Technical Service Bulletin

Cobra Motorcycle Mfg.

TSB0311 Kick Lever for older models

Cobra King and JR models 2010 and older use the ECDC0046 clamp style kick lever.

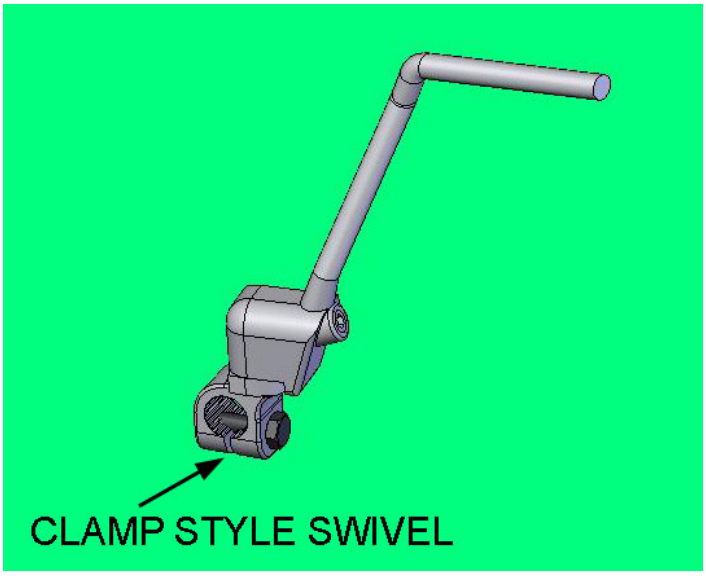
This kick lever assembly is no longer available for service replacement as the clamp style ‘pivot’ is now obsolete. We do still offer the following replacement parts to help service older units.

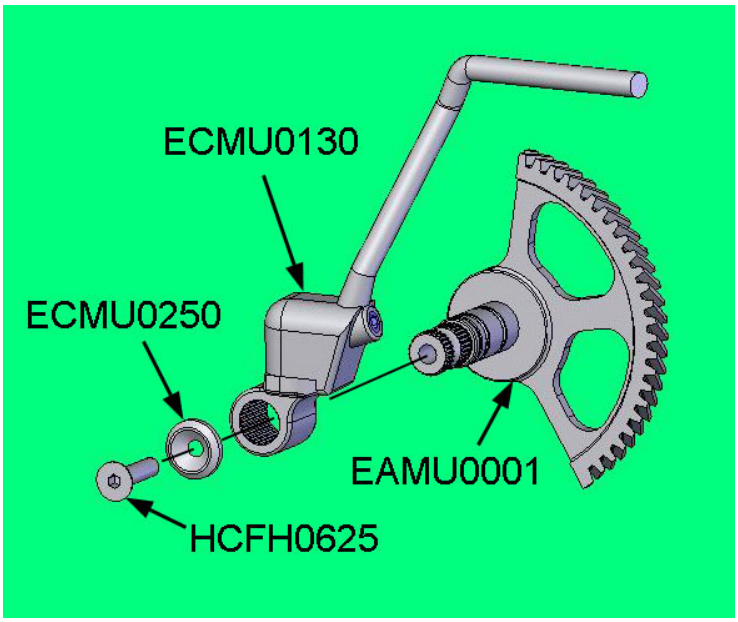
If a complete kick lever assembly is required, customers will be required to purchase a new style kick shaft/gear along with new style kick lever assembly.

If the threads strip out of the ECDC0046 swivel, a longer bolt with a nut may be an option, or likewise a heli-coil, may be a cost effective alternative to purchasing a new kick lever and gear.
